**Economic Commission for Europe**
**Inland Transport Committee**
**World Forum for Harmonization of Vehicle Regulations**
**Working Party on Brakes and Running Gear**
**Eightieth session**

Geneva, 15–18 September 2015

**Report of the Working Party on Brakes and Running Gear  
on its eightieth session**
**Contents**

Figure 25 a

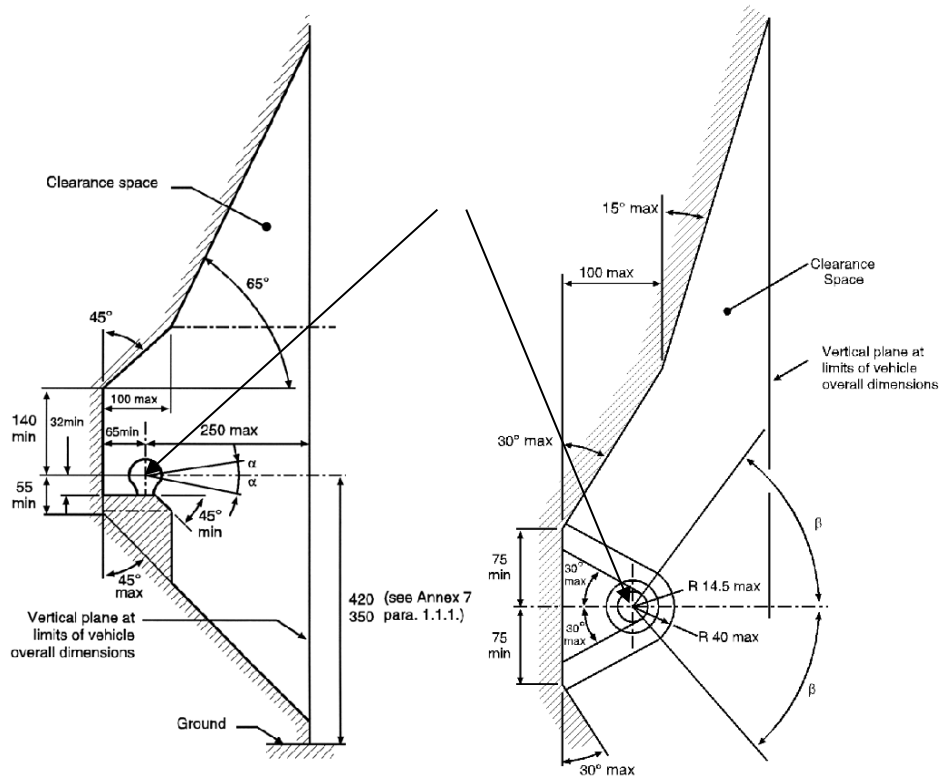
1.1.1.1. The clearance space shown in Figures 25a and 25b may be occupied by non-demountable equipment, such as a spare wheel, provided that the distance from the **centre** of the ball **or the centre of the hook** on a vertical plane at the extreme rearmost point of the equipment does not exceed ~~300 mm~~ **250 mm**. The equipment shall be mounted to allow adequate access for coupling and uncoupling without risk of injury to the user and without affecting articulation of the coupling.

is rotated horizontally 60° to right or left, ( $\beta = 60^\circ$ , see Figure 25);

is rotated vertically 10° up or down ( $\alpha = 10^\circ$ , see Figure 25);
